## Addendum #1 Spearman HVAC

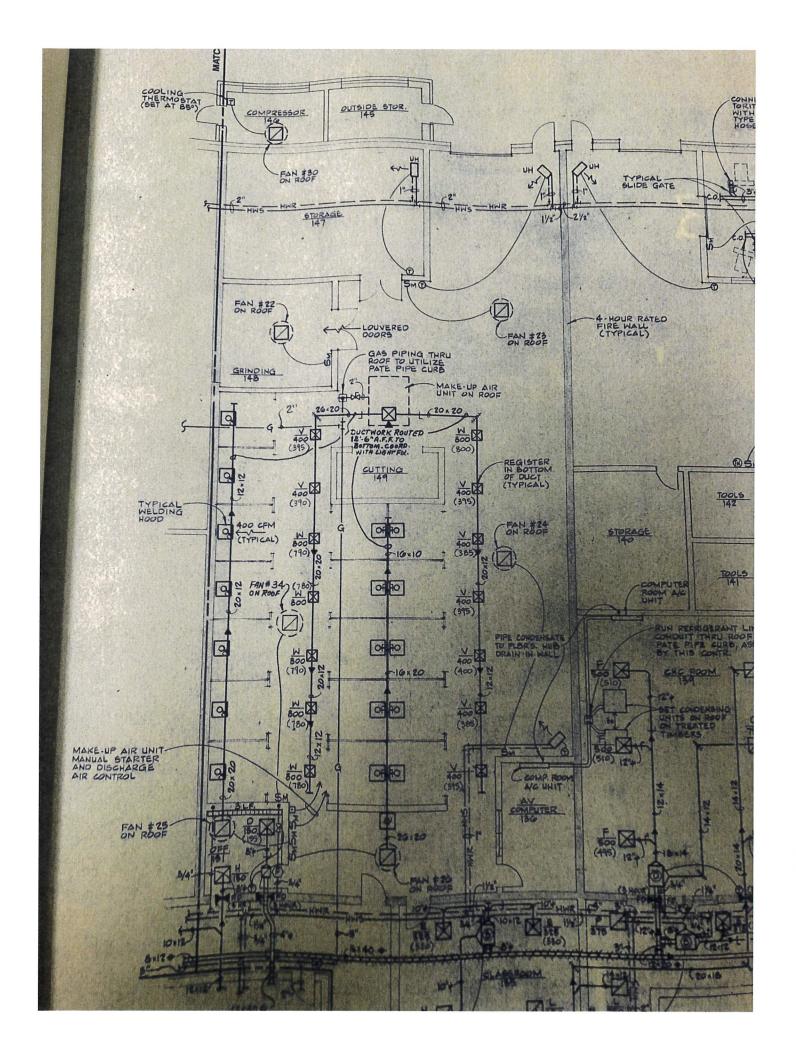
Requested information for the fan schedule and layout is included.
